## **Frodsham Solar**

#### **Appendix 9-1: Flood Risk Assessment and Drainage Strategy Part 1 of 5**

Document Ref: EN010153/DR/6.2

## Flood Risk Assessment & Drainage Strategy

**Figure 1 – Mersey Breach Location**

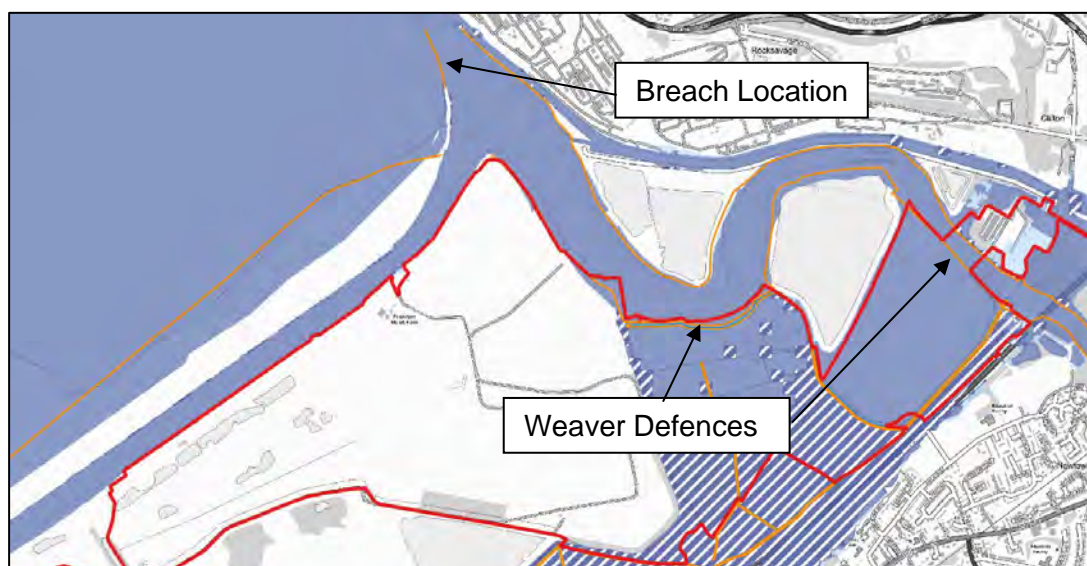
Figure 1 shows the proposed breach location. Please can you confirm the breach location is acceptable.

**Figure 2 – Weaver Breach Location**

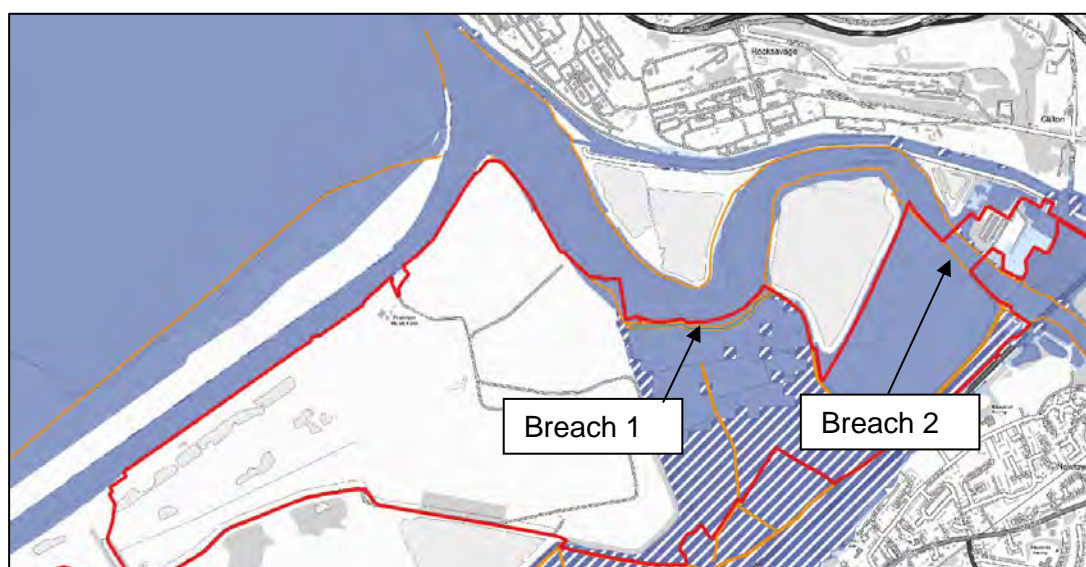
For the River Weaver breach scenario, we propose 2no. breaches in separate locations shown in Figure 2 below. Please can you confirm that the breach locations are acceptable?

**Figure 1 – Flood Defence Locations**

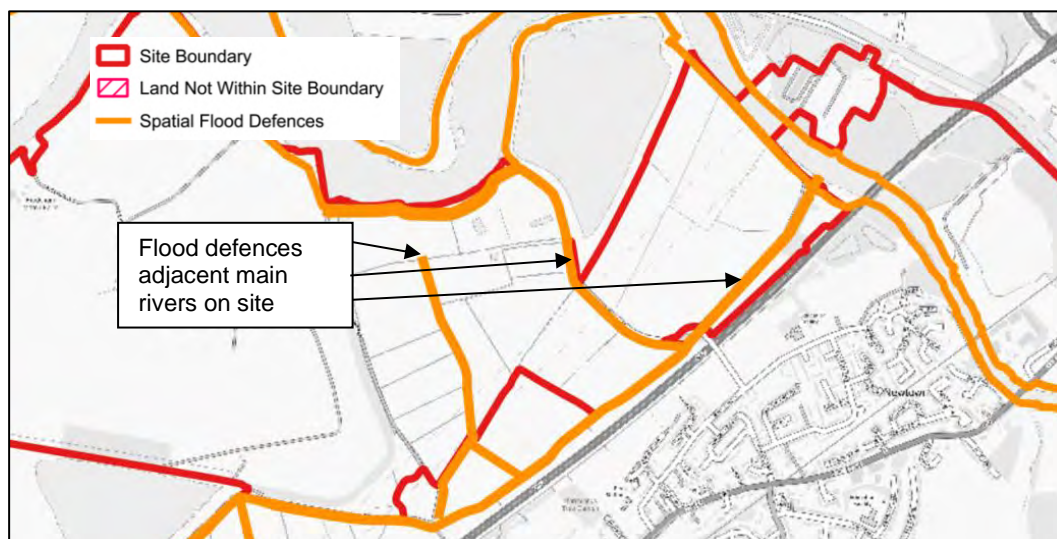
In relation to flood defences offsets, the site layout design provides a 16m offset to the flood defences which adjoin the River Weaver. It is acknowledged that these defences would play a role in defending the site from tidal flooding. We seek further clarification on the offset for the flood defences along the designated 'main rivers' which flow through the site. The defences in question are identified in Figure 1.

Figure 2 – On Site Watercourse Designation

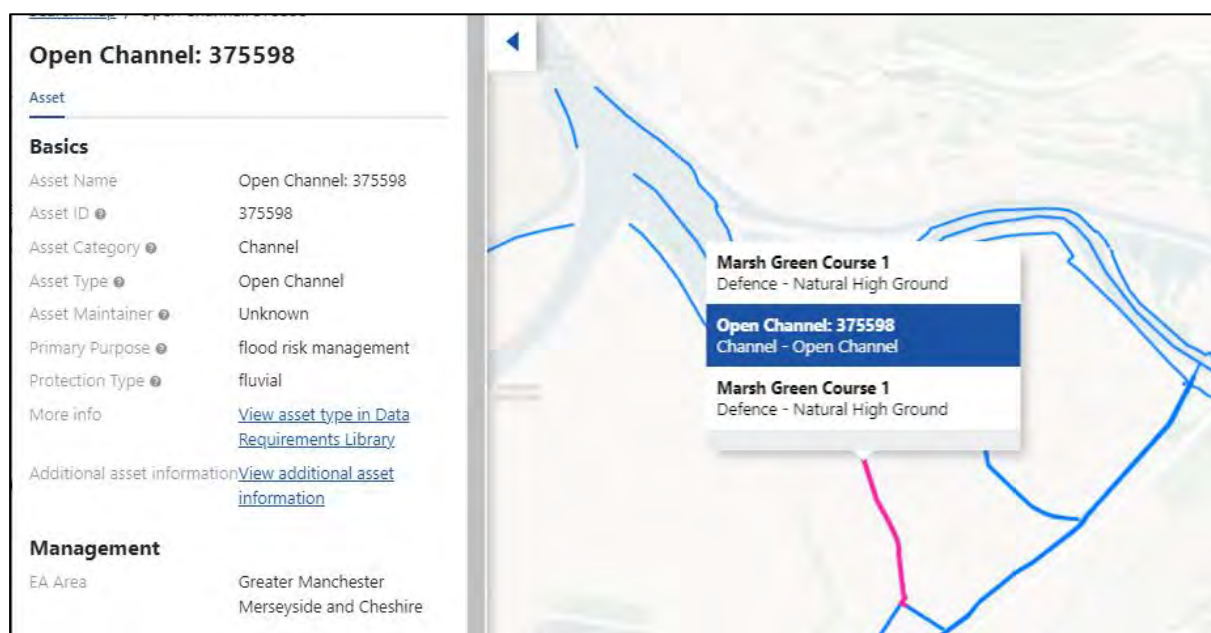
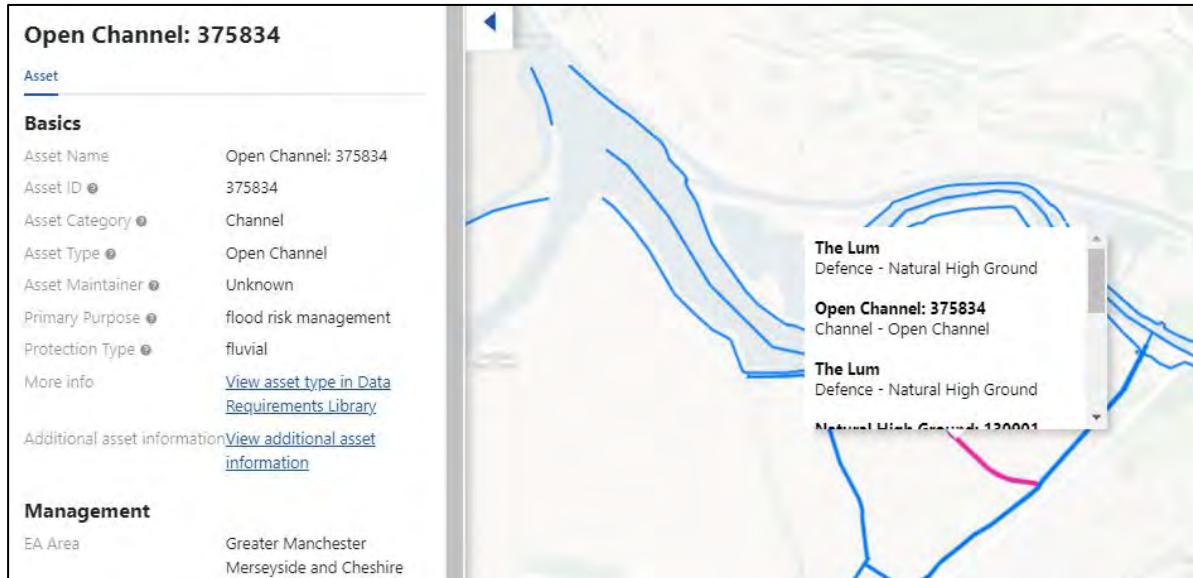
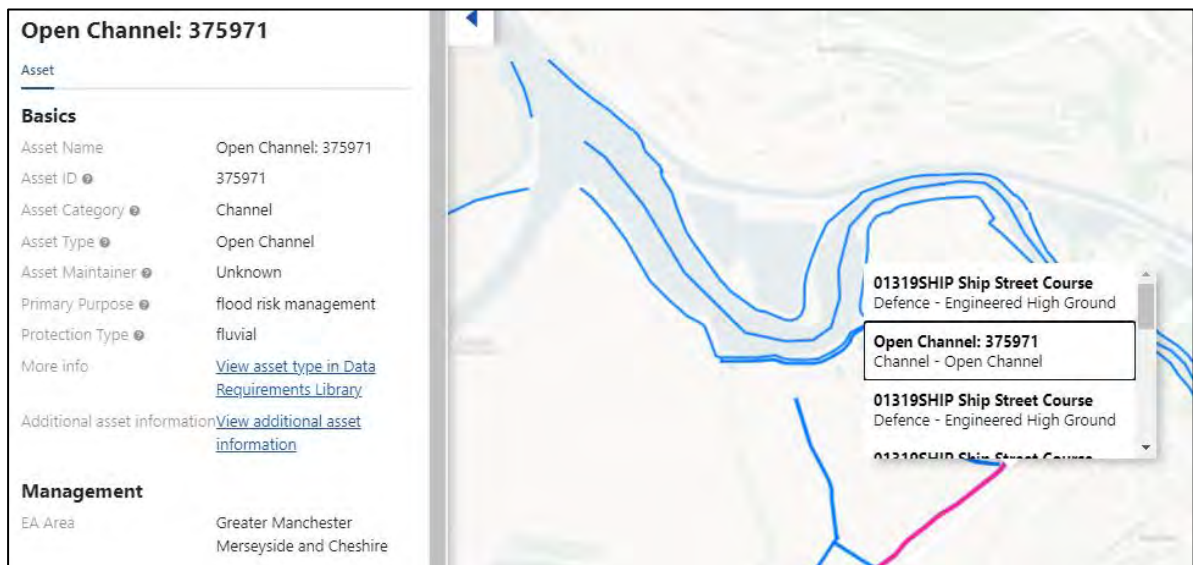
Using the EA 'Asset Information and Maintenance Programme' data (data.gov.uk), the main rivers on site are designated as being 'fluvial'. This is shown in Figures 2 – 4 below. The watercourses do not convey any tidal flows. As such, the flood defences adjacent to these watercourses, designated as high ground, do not have any role in protecting the site from tidal flooding (from the Mersey). We therefore propose that an 8m offset is applied as the defences provide protection against a fluvial flood source.

Please could you advise if the 8m offset is agreeable to the flood defences classified as 'high ground' within the site. Should further clarification be required, please provide further guidance on the measurement of horizontal offset i.e. do the EA have guidance on how this should be measured.
